SUBJECT: Rolls-Royce Response to Request for Additional Information Re: Rolls-Royce Civil Nuclear "**SPINLINE 3** Digital Safety Instrumentation and Control Platform" Topical Report (TAC NO. ME3600)

RESPONSE TO REQUEST FOR ADDITIONAL INFORMATION
ROLLS-ROYCE **SPINLINE 3** DIGITAL SAFETY
INSTRUMENTATION AND CONTROL PLATFORM
PROJECT NO. 773

The following request for additional information (RAI) questions address regulatory evaluation criteria for the Rolls-Royce **SPINLINE 3** Platform Licensing Topical Report (LTR). The topics covered in this set of RAI questions include: follow-up items requesting clarification of earlier RAI responses, Rolls-Royce's configuration management program, and Rolls-Royce's independent verification and validation (V&V) program.

Figure 1: **SPINLINE 3** Backplane – Schematic Representation

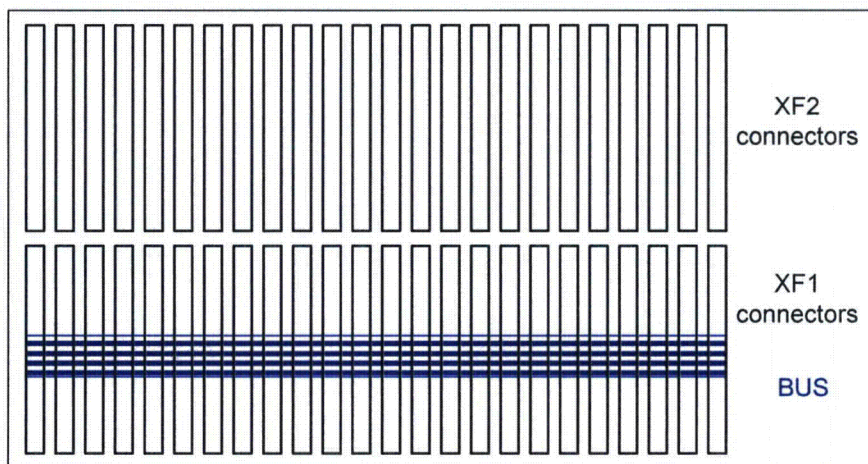
RAI-31 (Follow-up question for RAI-1 and RAI-3) - RAI-1 and RAI-3 requested information about data communication from the input/output (I/O) boards to the UC25 N+ central processing unit (CPU) board and back.

The responses provided for these 2 RAI questions illustrate how the data is transferred through the backplane bus (BAP). Also, from the information provided, the NRC staff understands that the BAP is a Master/Slave parallel bus, controlled by the UC25 N+ CPU board, to address the I/O boards. This response states that the BAP uses a "Rolls-Royce proprietary secure protocol."

Further, the response to RAI-3 states: "The address of a given board, in a given position in the rack, is set during the design phase by a hardwired connection of specific pins on the backplane panel. This address is associated to the location of the board in the rack in its position. To read or write information to or from a given board, the operating system software (OSS) sets the relevant bits of the address bus. A board is then addressed when the bits on the address bus are equivalent to the address wired on the backplane panel."

Rolls-Royce Answer – The following response addresses the collective NRC question for ease of understanding rather than trying to address each subpart separately.

- A metallic frame consisting of riveted and bolted parts, galvanized and chromate passivated, designed for electromagnetic protection and mechanical strength.
- Mounting rails for easy insertion and retrieval during maintenance.
- A backplane which provides two functions: [[

The standard backplane with 21 slots is shown in Figure 1 below.
